DeKalb County Historic Preservation Commission

Staff Report

G. 1071 Oxford Road, Dan Hanlon. Construct a second-story addition and demolish a porte cochere and enclosed porch on a historic house. **1247715**.

PRELIMINARY SITE PLAN

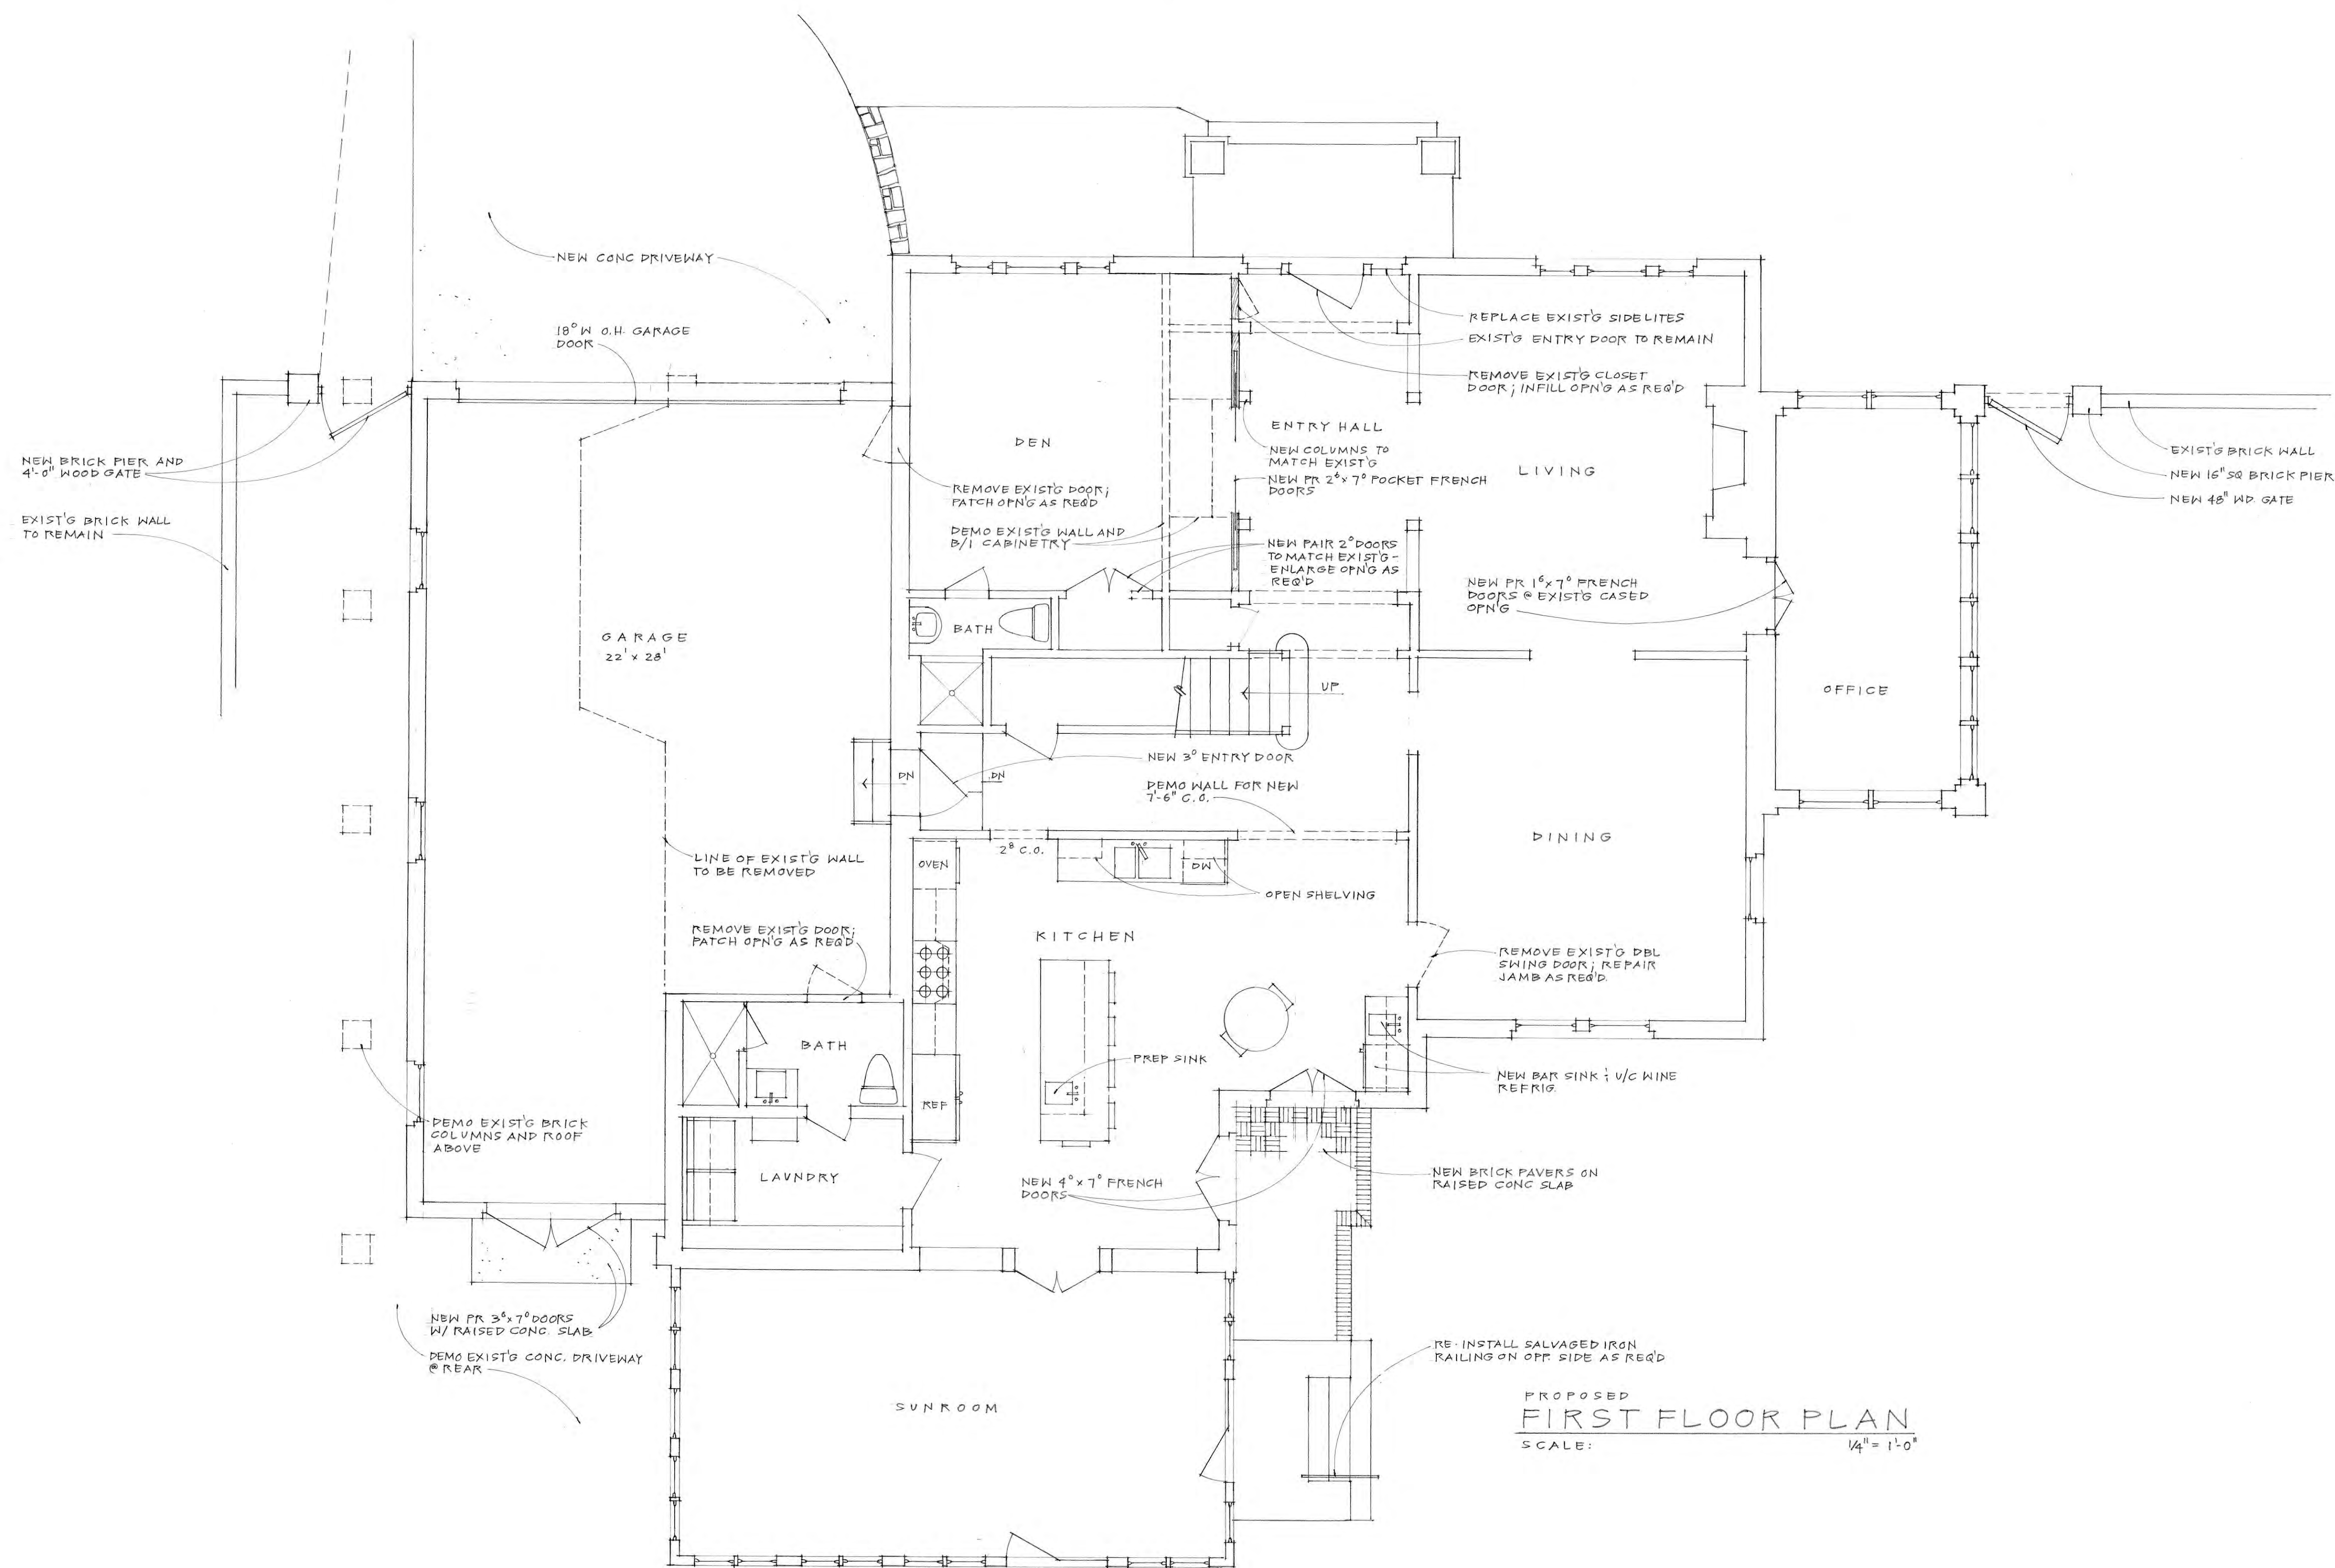
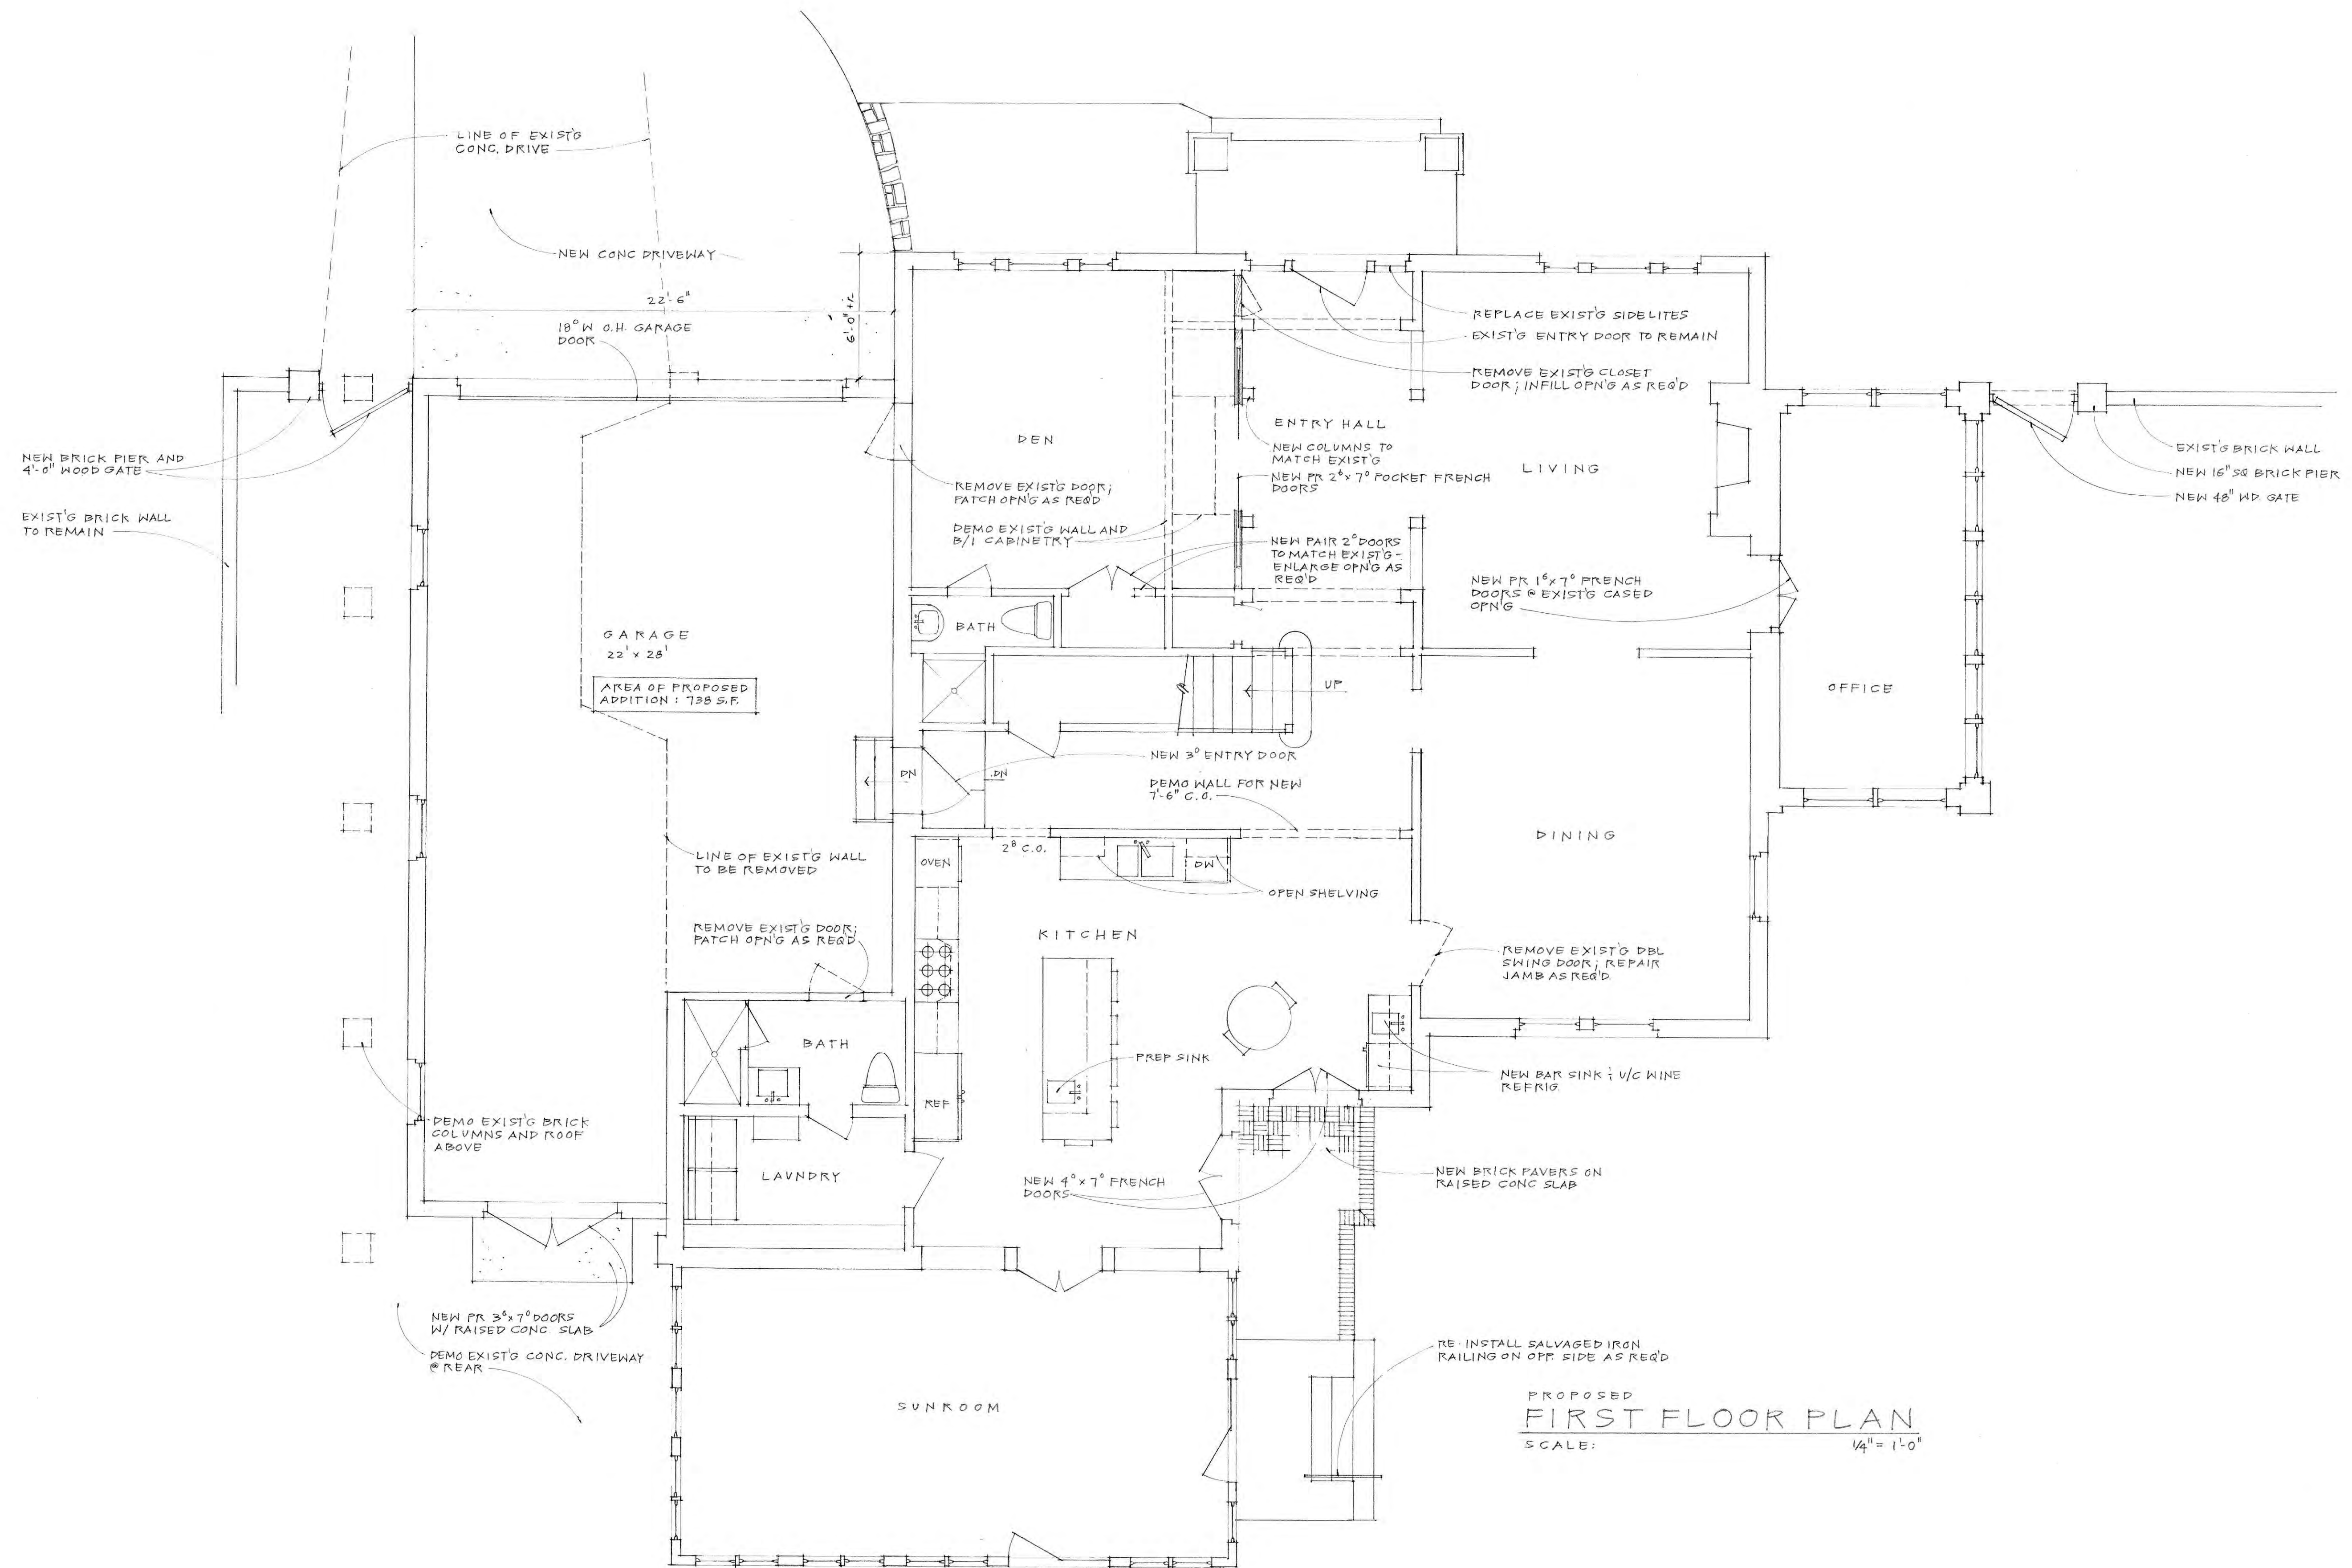
THE PROPOSED LOT COVERAGE IS 43.51%. THIS IS GREATER THAN THE MAXIMUM ALLOWED LOT COVERAGE OF 35.00%.
HOWEVER, THE EXISTING LOT COVERAGE IS 46.00%.
THE PROPOSED PLAN PROVIDES A REDUCTION IN THE LOT COVERAGE.
